SERVICE BULLETIN

SUBJECT: ELECTRICAL POWER – Modification of Static Inverter Part Number 1-002-0102-2173 to Part Number 1-002-0102-2573.

TRANSMITTAL: Service Bulletin 1-002-0102-2573-24-44 Initial Release (Revision 0).

1-002-0102-2573-24-44

Figure 1

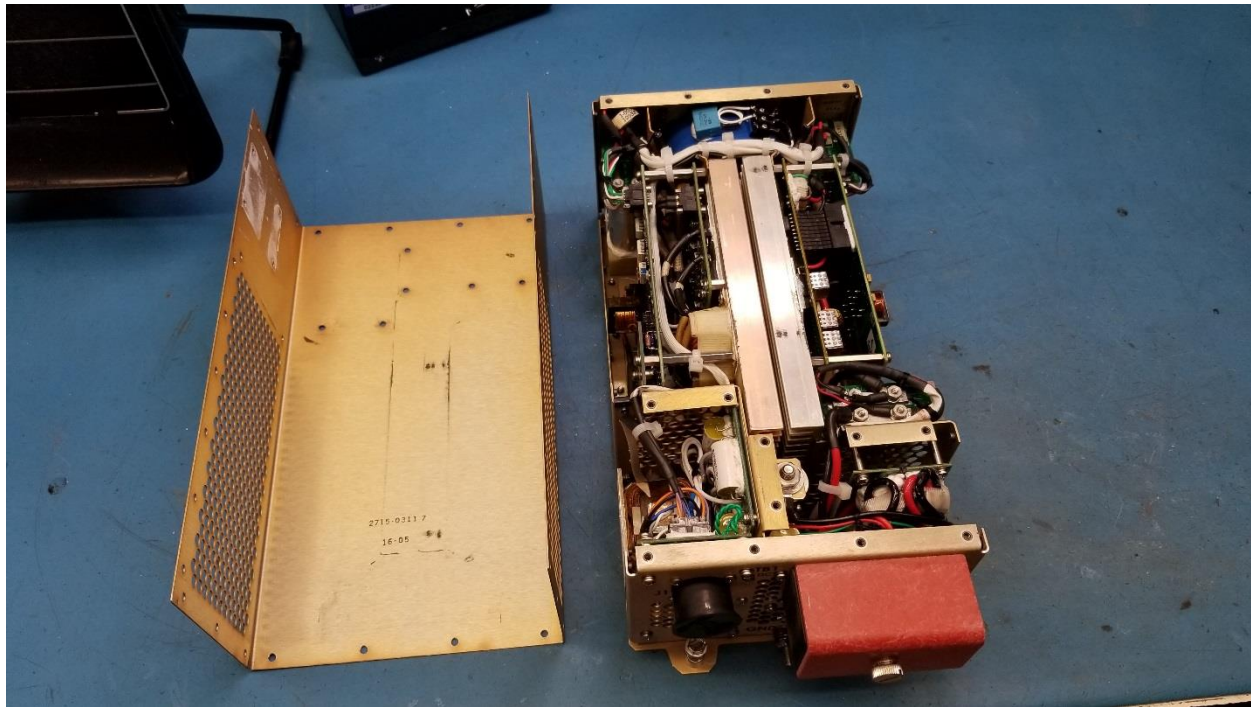
1. Remove 48 screws (51957-12) from the cover of the unit. (Figure 1).
2. Remove the cover from the unit. (Figure 2)
3. Disconnect the transformer from the base plate by removing (4) screws (24693-C2) from the base of the unit. (Circled in yellow). (Figure 3).

44. Secure the wires with grommet (1-001-0204-0029, Type 6/6). Secure the cables with cable tie (MS3367-5-9). (Figure 28, Figure 29)
45. Reinstall the top cover of the unit by inserting (48) screws (51957-12) into the unit. (Figure 1, Figure 2).

Figure 3

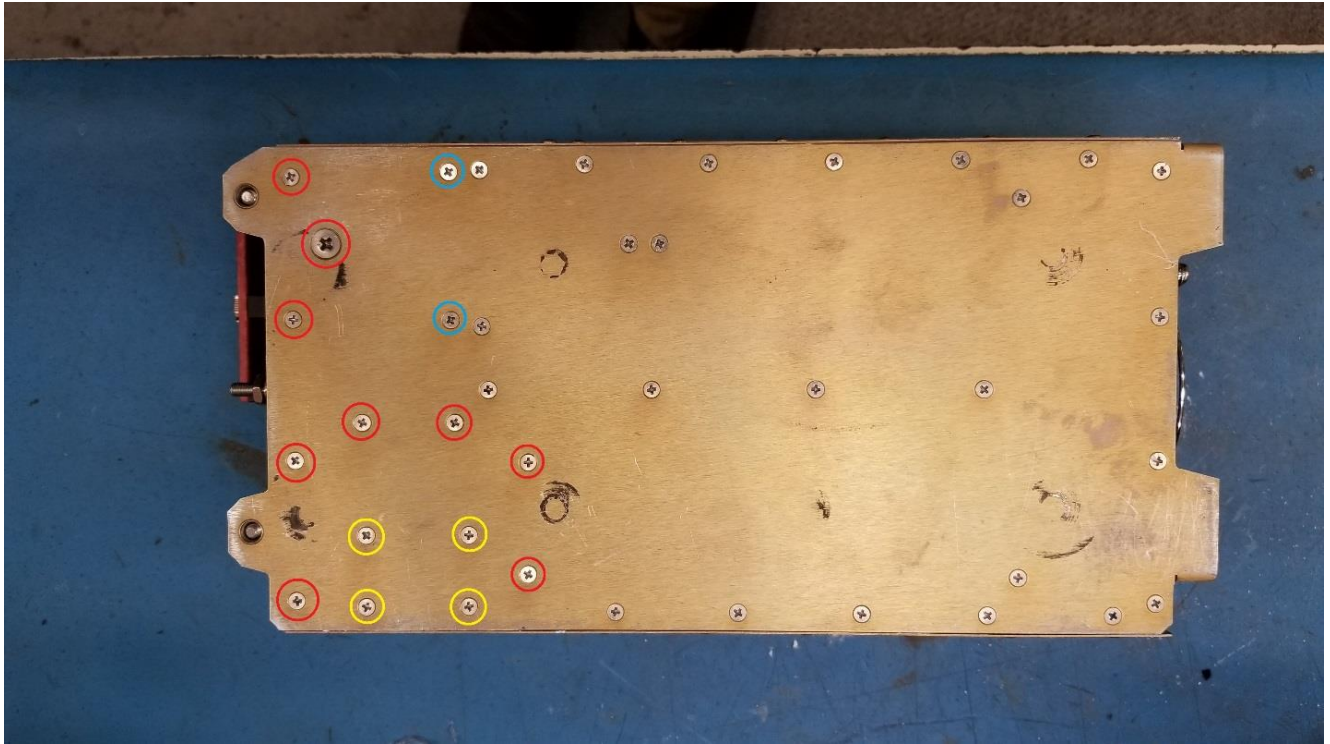
4. Disconnect the PCB EMI Input/Bracket assembly from the base plate by removing (2) screws (24693-C2) from the base of the unit. (Circled in blue). (Figure 3).

5. Disconnect the Front panel Assembly from the base plate by removing (8) screws (24693-C2) and (1) screw (24693-C273) from the base of the unit. (Circled in red). (Figure 3).

39. Reinstall the transformer to the base plate by inserting (4) screws (24693-C2) to the base of the unit. (Circled in yellow). (Figure 3).
40. Reinstall the PCB EMI Input/Bracket assembly to the base plate by inserting (2) screws (24693-C2) into the base of the unit. (Circled in blue). (Figure 3).

41. Connect the Front panel Assembly to the base plate by inserting (8) screws (24693-C2) and (1) screw (24693-C273) into the base of the unit. (Circled in red). (Figure 3).

Figure 5

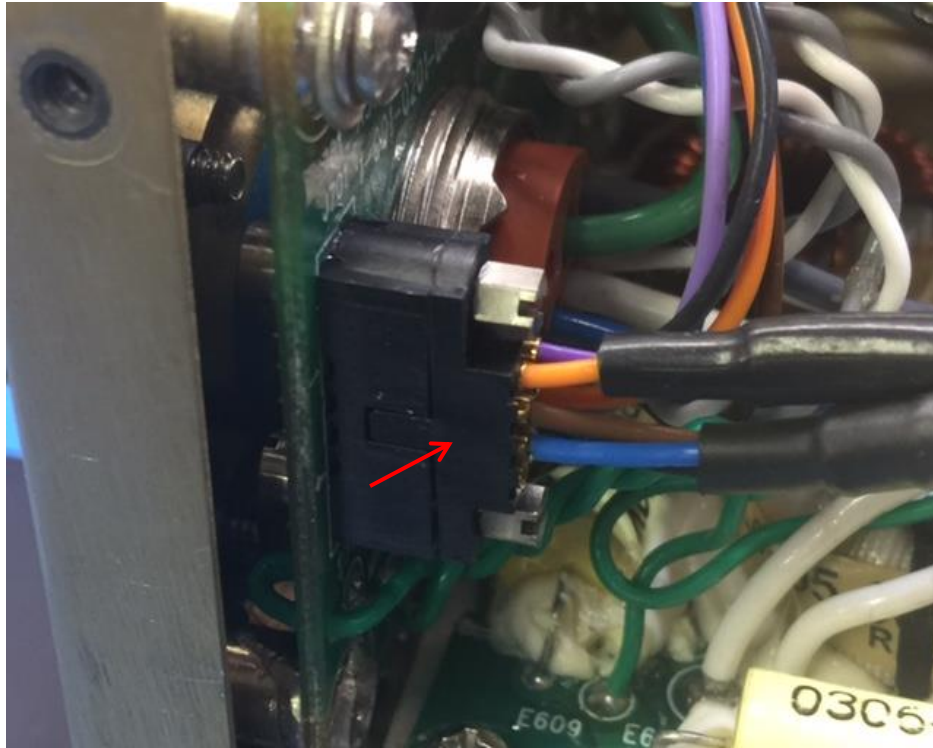
6. Disconnect the connector from the AC connector/ alarm assembly. (Figure 5, Figure 6).
7. Disconnect the wires/cables by de-soldering at locations E602, E603, E605, E608, E609 and E610 on the EMI Output board assembly (Soldering Iron tip JBC C245-741). (Figure 7, Figure 8, Figure 9, Figure 10, Figure 11, Figure 12).

42. Connect (4) lugs by attaching (4) nuts (35649-245T), (4) washers (15795-803), (4) washers (35338-135) and shrink tubing (M23053/5). (Figure 20).
43. Connect the connector from the AC connector/alarm assembly (1-002-0108-0255). (Figure 5, Figure 6).

Figure 7

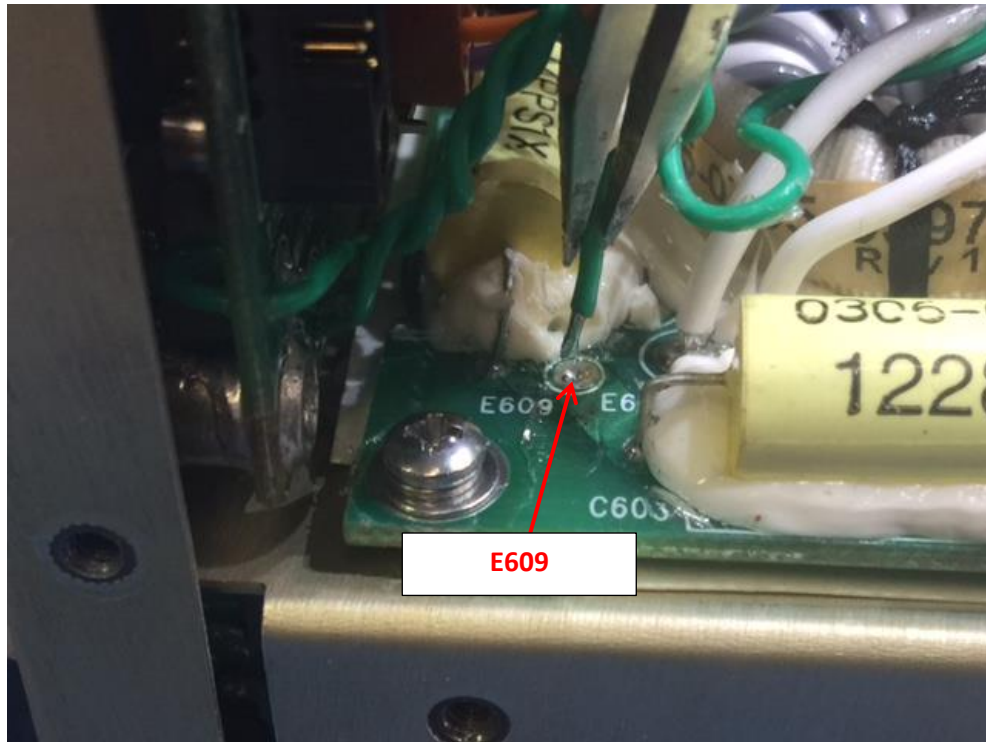
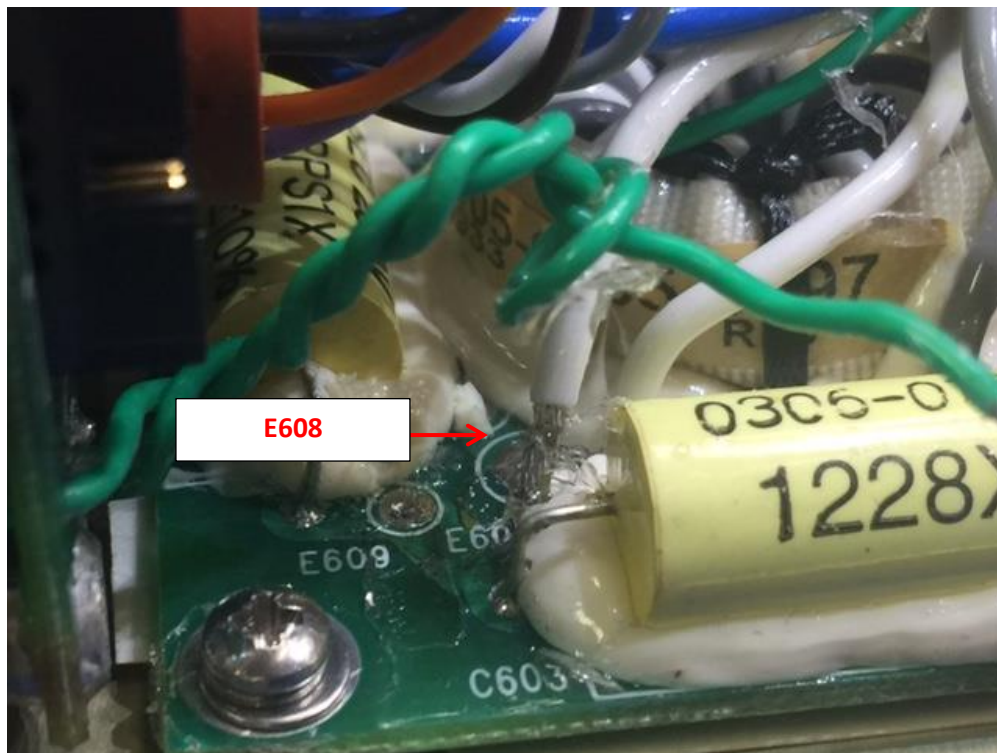
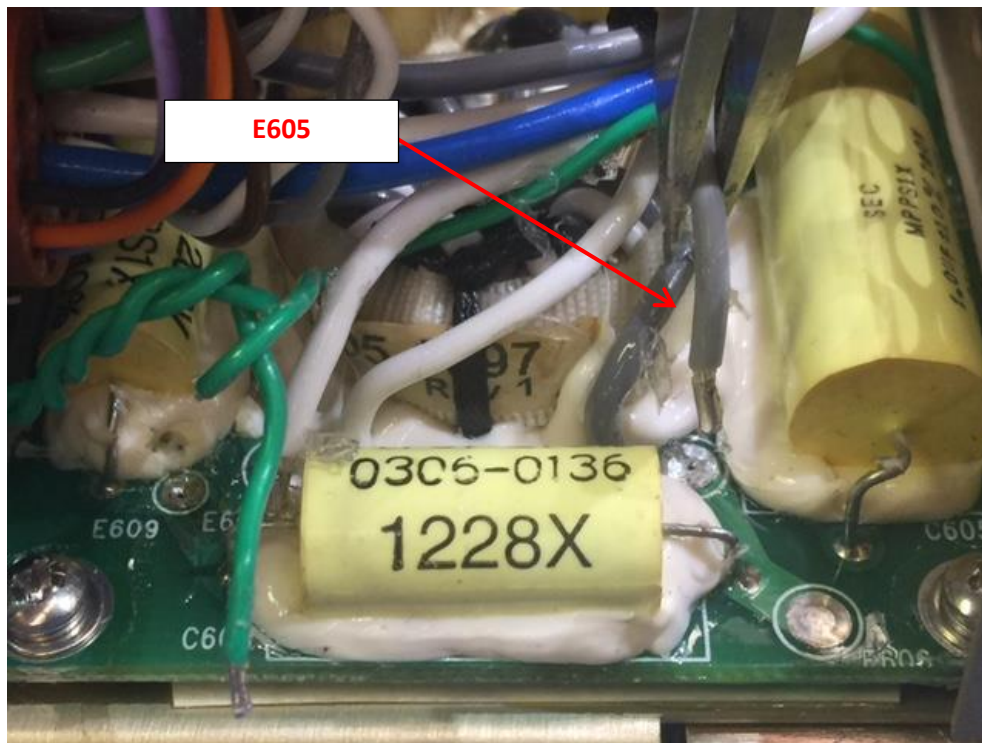
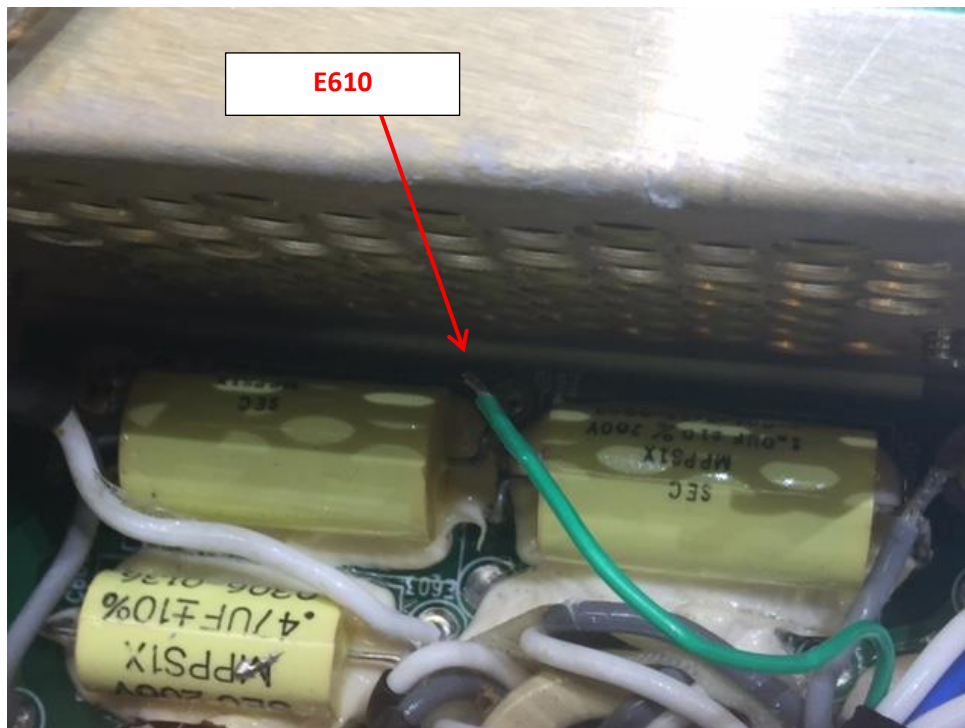
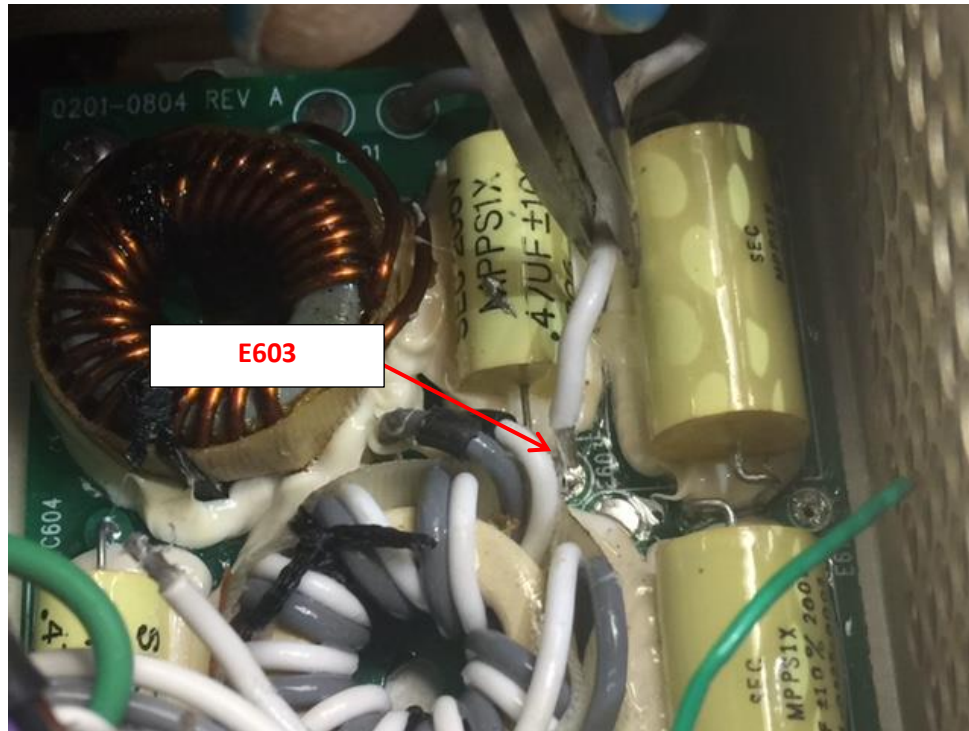
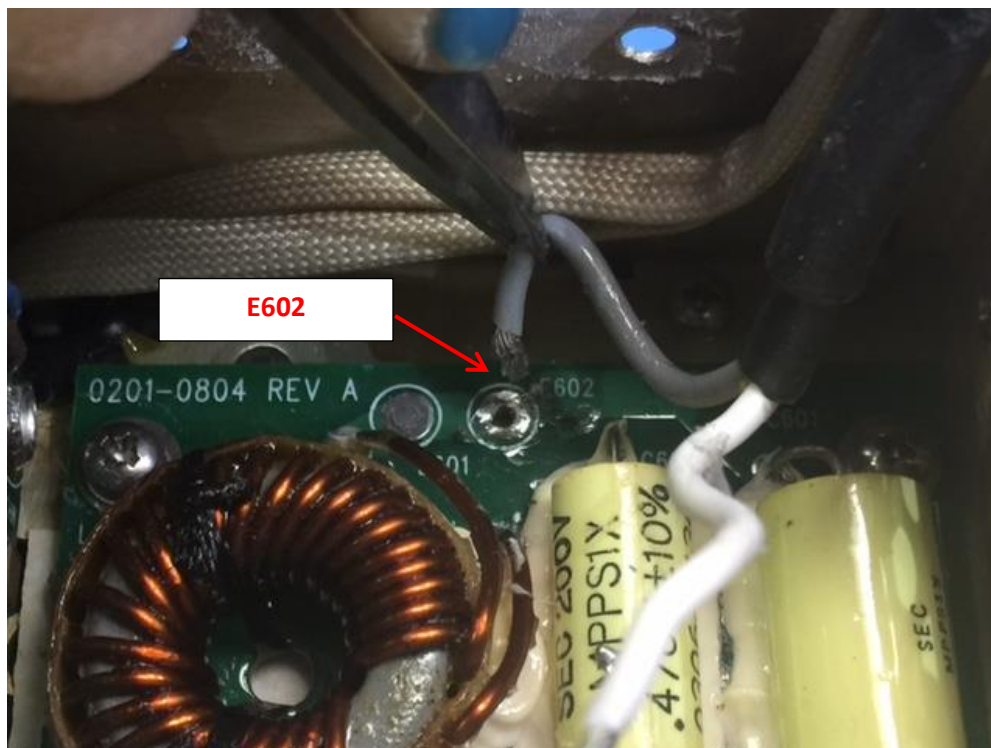
15. Apply RTV (MIL-A-46146) around the capacitors. (Figure 17, Figure 18).
16. Manually brush capacitors (top surface & soldered areas) with conformal coating (MIL-I-46058).
17. On the reverse side of the EMI output assembly, place the (2) new labels (1-001-2503-0001) which show the new part number of the assembly (1-002-0108-0395), manually brush areas with conformal coating (MIL-I-46058). (Figure 19 (label in red area)).
18. Assemble the repaired EMI output assembly (1-002-01008-0256) onto the EMI shield using (4) screws/washers.
19. Solder wires/cables at locations E602, E603, E605, E608, E609 & E610 on the EMI Output board assembly using solder wire (1-001-2301-0002, CLEANLINE 7000, 0.032"DIA, 63 SN 37 PB 2% FLUX)) and soldering iron (tip JBC C245-906 or equivalent). (Figure 7, Figure 8, Figure 9, Figure 10, Figure 11, Figure 12).

Figure 13

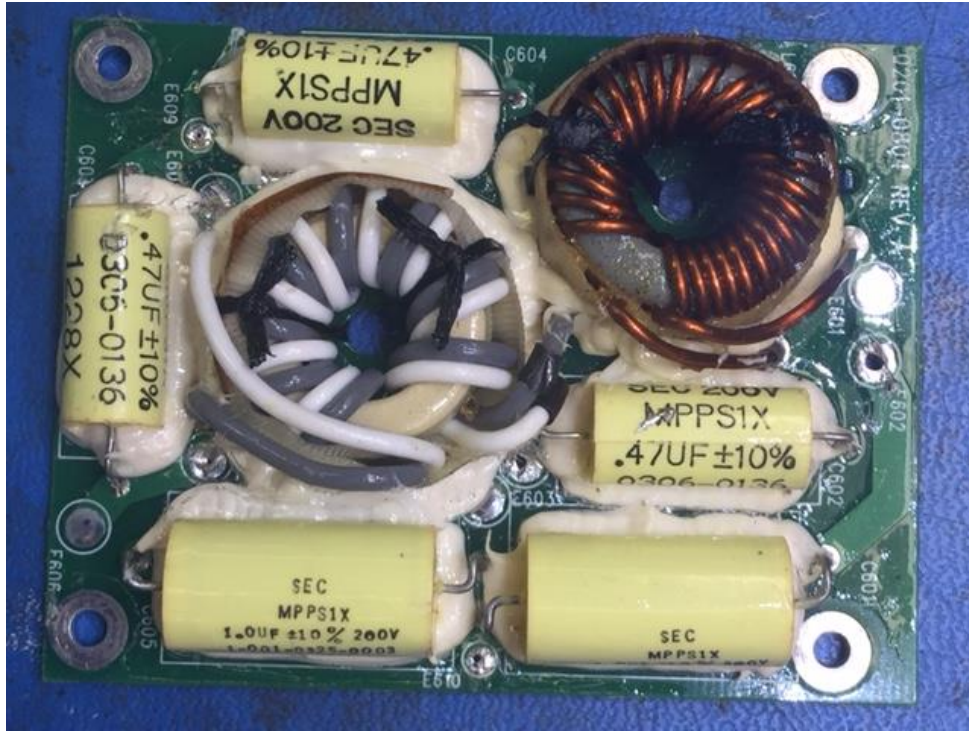
8. Remove EMI Output Assembly from EMI shield by removing (4) screws and washers. (Figure 13).
9. Remove capacitors by cutting leads with a cutter. (Figure 14).

Figure 15

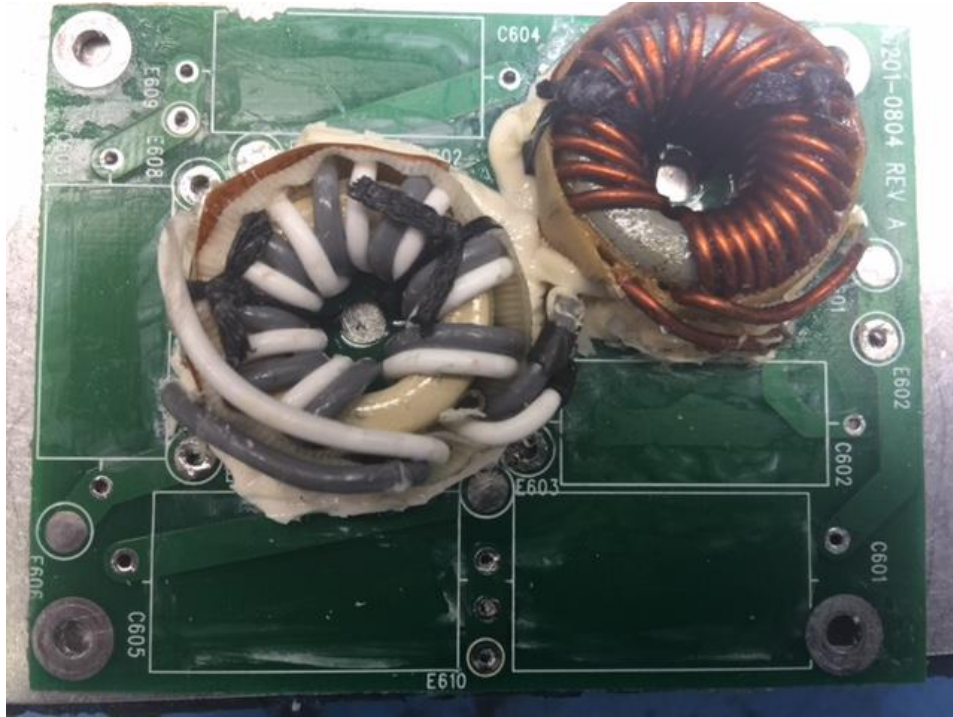
12. Manually clean the PCB holes with alcohol.
13. Apply thinner (1-001-2302-0019, T521-5L) over the old RTV and peel it off after 5 mins of dwell time. (Figure 15).

Figure 16

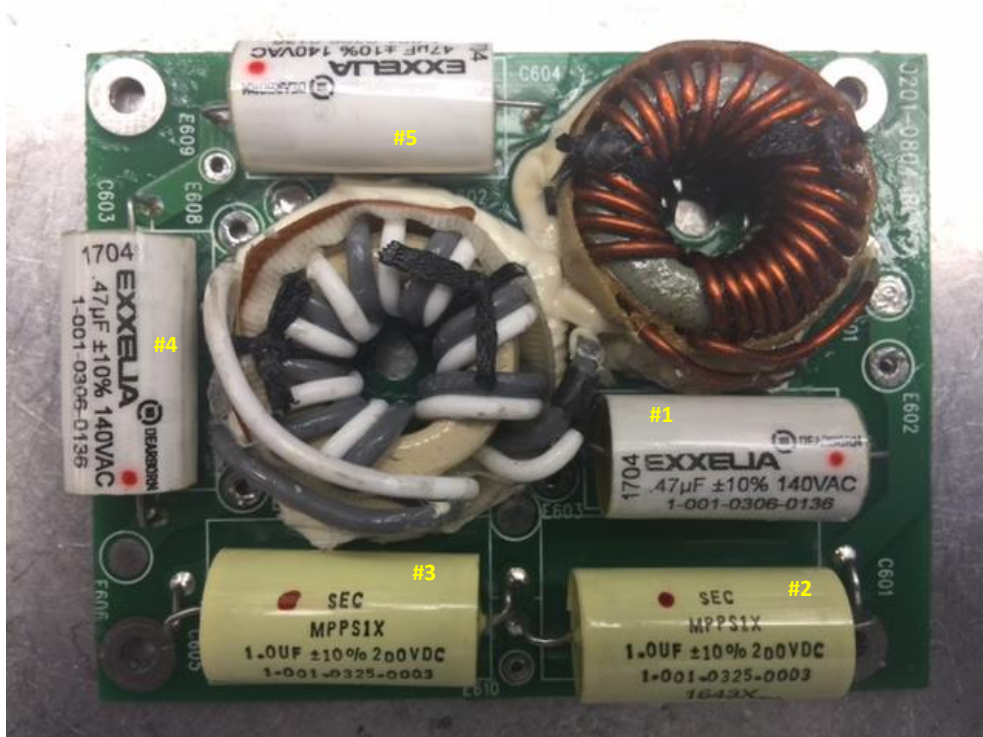
14. Sequentially (#1-5) install and solder the new capacitors (1-001-0325-0003 (2), 1-001-0306-0136 (3)). Solder top & bottom lead of capacitors using solder wire (1-001-2301-0002, CLEANLINE 7000, 0.032"DIA, 63 SN 37 PB 2% FLUX)) and soldering iron (tip JBC C245-906 or equivalent) set at 650F. Manually clean soldered areas with alcohol. (Figure 16).

Make sure the capacitors have "Red" dot marking on top to indicate quality screening (burn-in).
Make sure the capacitors are installed with correct orientation.

Figure 20

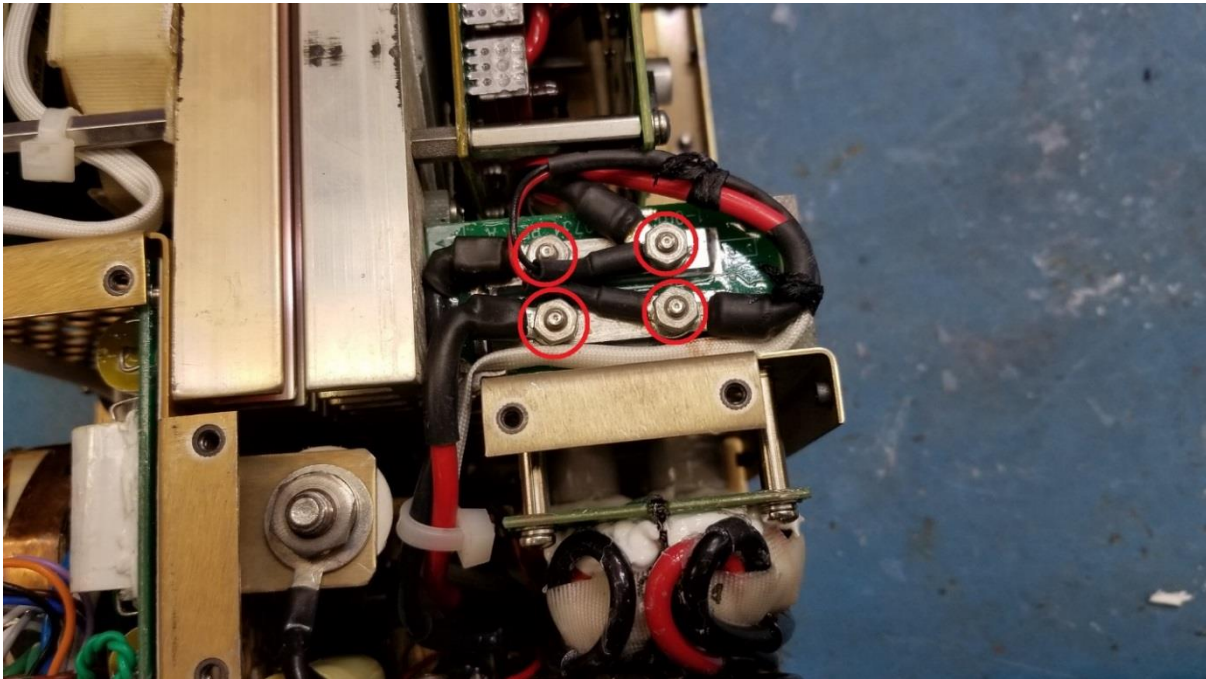
20. Apply conformal coating (MIL-I-46058) to the soldered areas.
21. Disconnect (4) lugs by removing (4) nuts (35649-245T), (4) washers (15795-803), (4) washers (35338-135) and shrink tubing (M23053/5). (Figure 20).
